**STAFF REPORT:****PERMIT AMENDMENT**

APPLICATION NUMBER:	<b>1-03-004-A1</b>
APPLICANT:	<b>Reclamation District 768</b>
AGENT:	Oscar Larson & Associates (Attn: Stein Coriell)
PROJECT LOCATION:	1,500-acre Reclamation District, including a 4.9-mile-long levee system, located north and south of Highway 255 along the northern shoreline of the Arcata Bay lobe of Humboldt Bay and the banks of Mad River Slough, Arcata Bottom area, Humboldt County.
DESCRIPTION OF PROJECT PREVIOUSLY APPROVED:	Repair of a 230-foot-long breach in a portion of the levee north of Hwy 255, replacement of three 36-inch-diameter culverts and floodgates, and a 10-year permit for routine repair and maintenance activities on the levee system.
DESCRIPTION OF AMENDMENT REQUEST:	Amend the project description to include the proposed "2007 Levee Repair Project", which would repair and/or protect approximately 7,877 linear feet (~1.5 miles) of eroded and damaged levee in 2007.

1 PLAN - TEMPORARY DITCH CROSSING - CULVERT  
SCALE: NTS

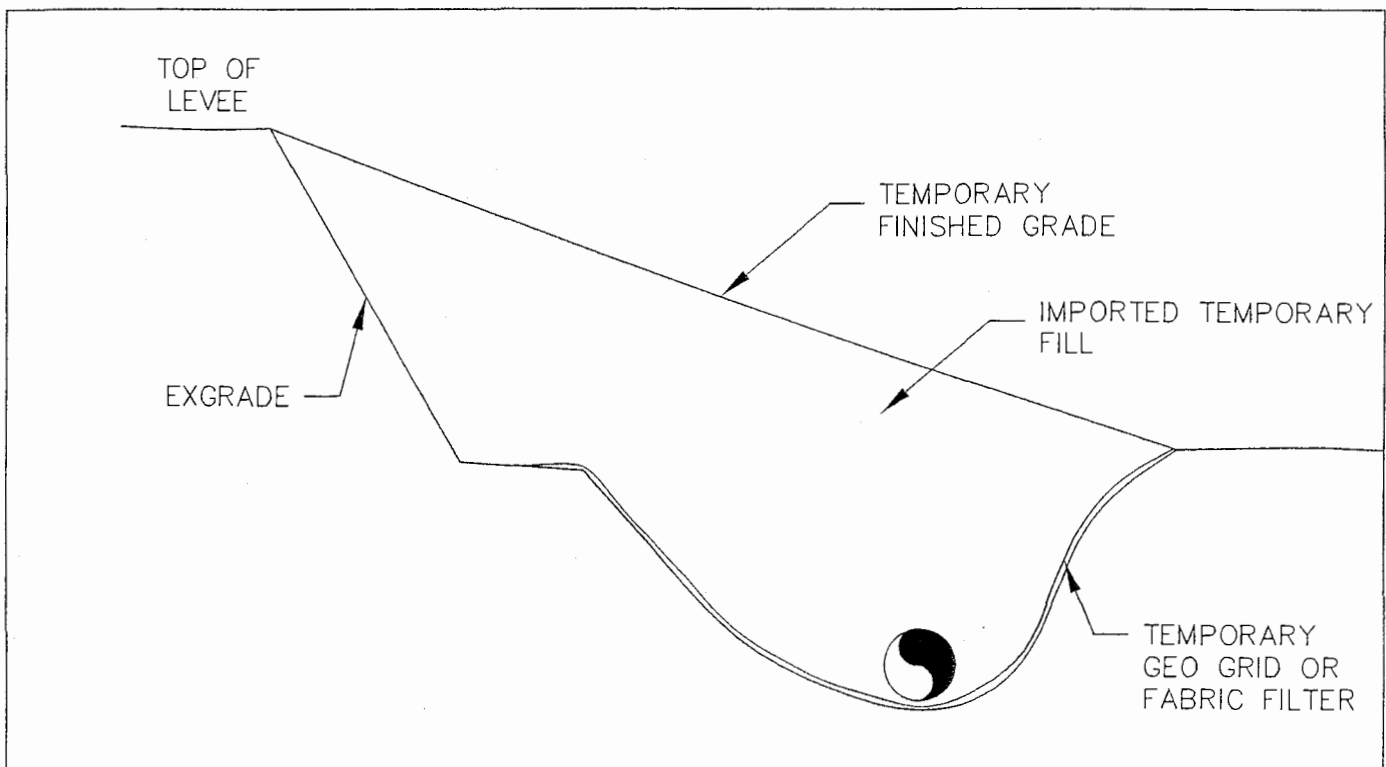
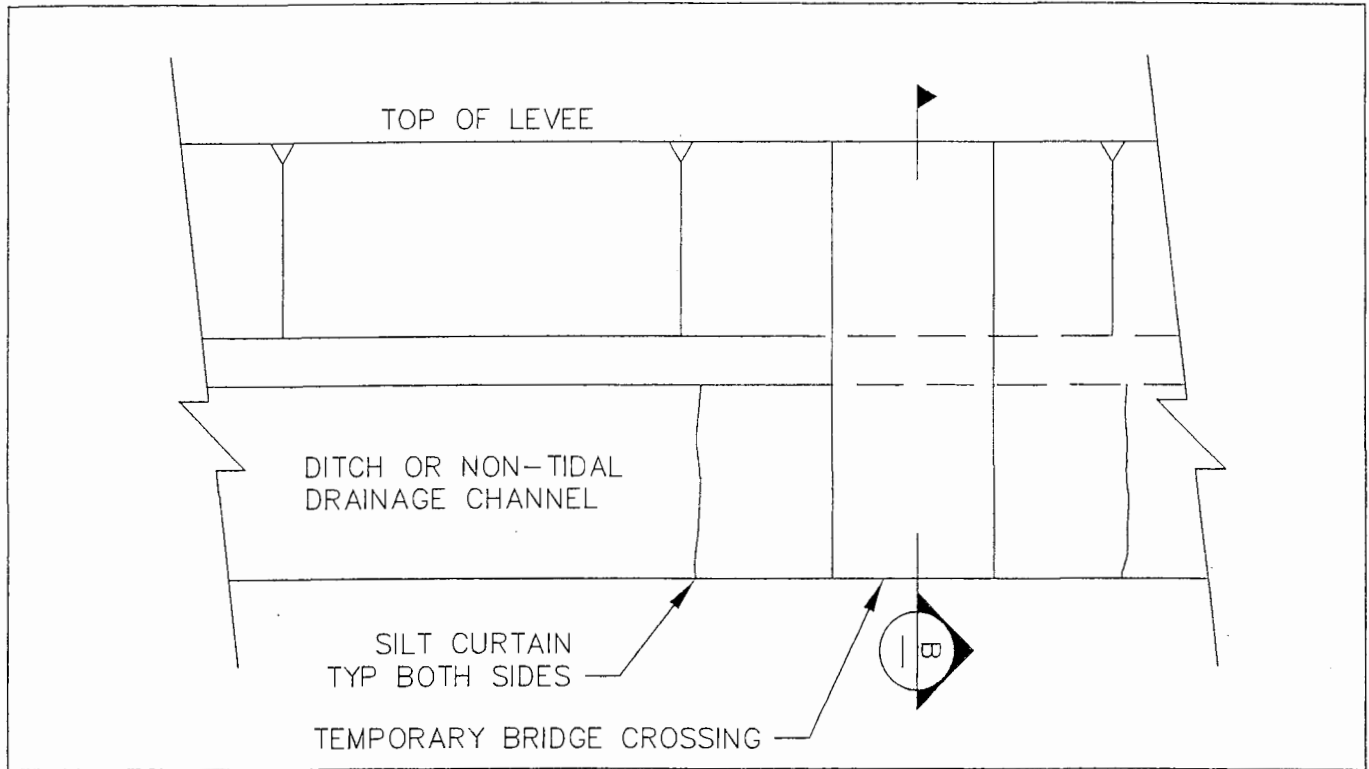
Second, one of two proposed methods for temporary ditch crossings is not the least environmentally damaging feasible alternative. This method involves installing a culvert within the ditch (placed over a temporary fabric filter), and then placement of temporary imported fill for the crossing (see Figure 7 of Exhibit No. 3). The temporary culvert crossing is proposed to remain in place for a maximum of 30 days. Materials used in crossing construction are proposed to be placed on top of the levee (without side casting) or removed to dispose of at an authorized location.

- b. Temporary ditch crossings: The permittee shall use only the temporary bridge design for temporary ditch crossings, as depicted in Figure 8 of Exhibit No. 3. No culverts or fill shall be placed in ditches for temporary crossing purposes. Any temporary bridge crossing shall remain in place for no more than 30 days maximum.**

2 PLAN - TEMPORARY DITCH CROSSING - BRIDGE  
SCALE: NTS

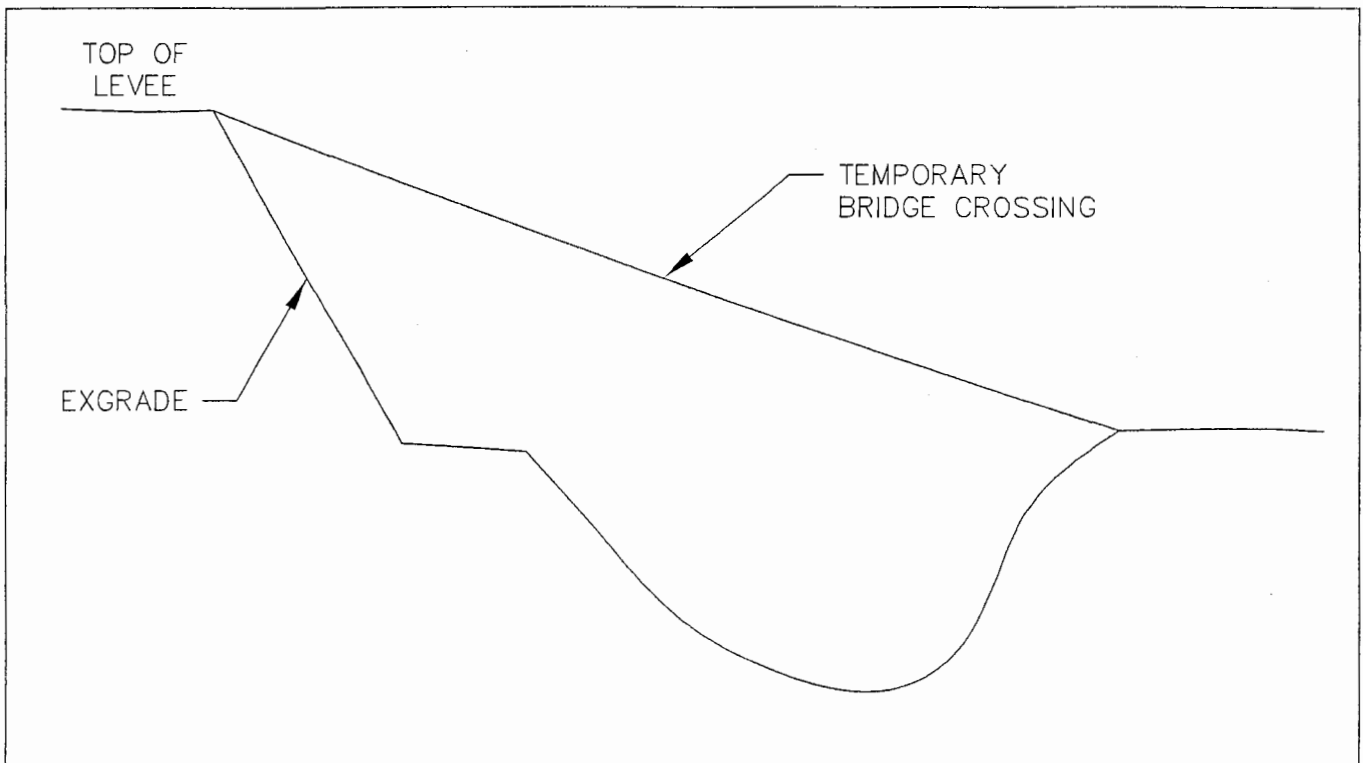
A less environmentally damaging feasible alternative method for minimizing impacts to ditch wetlands due to temporary crossing installation is the applicant's other proposed alternative. This alternative would not involve culvert or fill placement within wetland ditches. Instead, a temporary bridge would be placed over ditches to allow crossing (see Figure 8 of Exhibit No. 3). Any temporary bridge crossing is proposed to remain in place for a maximum of 30 days. This method is less environmentally damaging because it does not unnecessarily place fill in ditch wetlands, which, if not completely removed following construction, could adversely affect water quality.

C. As specified in Special Condition No. 3-b above, the permittee shall use only the temporary bridge design for temporary ditch crossings, as depicted in Figure 8 of Exhibit No. 3. No culverts or fill shall be
